Appendix A – Design Changes Due to the Addition of the HI-STAR 190 Casks

Title: Atlas Railcar CLIN 4 Event 1 White Paper

Doc./Rev.: EIR-3016139-001

Project: 00225.03.0050 - DOE Atlas Railcar

Figure 3-1: Vertical Load from Longitudinal Transportation Loading

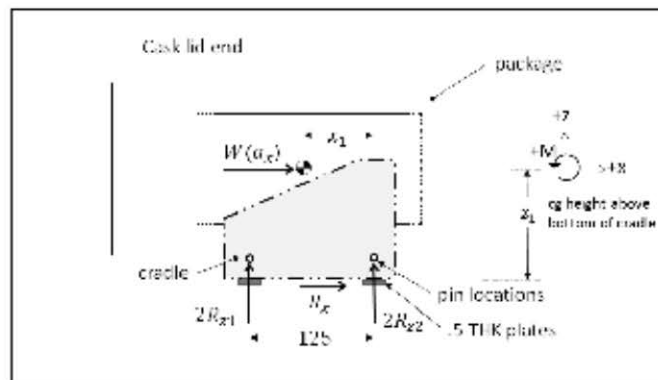
With the increased load due to the HI-STAR 190 XL weight, there was a concern that the attachment components center pin blocks would not be able to support the vertical and lateral transportation loads. The HI-STAR 190 XL loading configuration and vertical cg location were key in this evaluation. Holtec International confirmed that the cask could be positioned with the impact limiter at the minimum distance of 1 inch from the deck. (A 1 inch minimum clearance is required between the cask impact limiter and the railcar deck per Section 2.2.2.7 of [3]). This provided a vertical cask cg of half the cask impact limiter diameter plus 1 inch. Because of this low cg, even with the increased weight, the HI-STAR 190 XL was not bounding for the vertical load applied to the cradle attachment components. The bounding vertical load comes from the NAC MAGNATRAN cask, which although restrained in the longitudinal direction by the cradle attachment components shear block, applies a vertical load due to the longitudinal transportation load and the cask cg offset above the shear key (See the Figure 3-1 below). The HI-STAR 190 XL is restrained longitudinally by the end stops and the vertical transportation load (2g) is much smaller than the vertical reaction seen by the NAC MAGNATRAN due to the longitudinal transportation load (7.5 g).

The increased maximum weight from the HI-STAR 190 XL and revised loadings discussed above resulted in a reevaluation of the conceptual cradle attachment component design. The center four pin blocks were found to be acceptable as designed to support the increased lateral and vertical load. The outer pin blocks were moved outboard (see section "New Maximum Cask Length" below) and redesigned to combine the inboard and outboard outer pin blocks from separate blocks into a single piece as shown in Figure 3-3. This change increases strength and will provide an advantage in fabrication. The attachment pin material strength was also increased to accommodate the increased loadings.

Figure 3-2: Lateral Transportation Loading

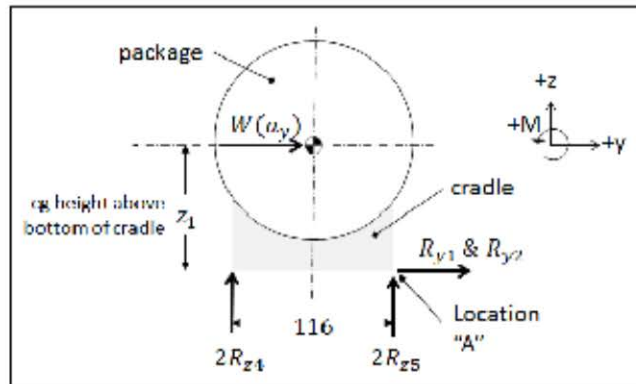
The HI-STAR 190 does provide a new bounding lateral load from the lateral transportation loading (which also applies a new bounding simultaneous vertical load). See the Figure 3-2 below.

Figure 3-3: Longitudinal Transportation Loading

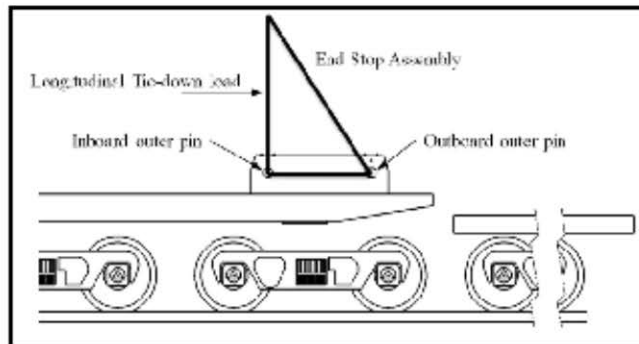
The HI-STAR 190 XL also provides an increased bounding load on the attachment components outer pin blocks due to the longitudinal transportation loading applied to the conceptual cradle end stops (see Figure 3-3 below).
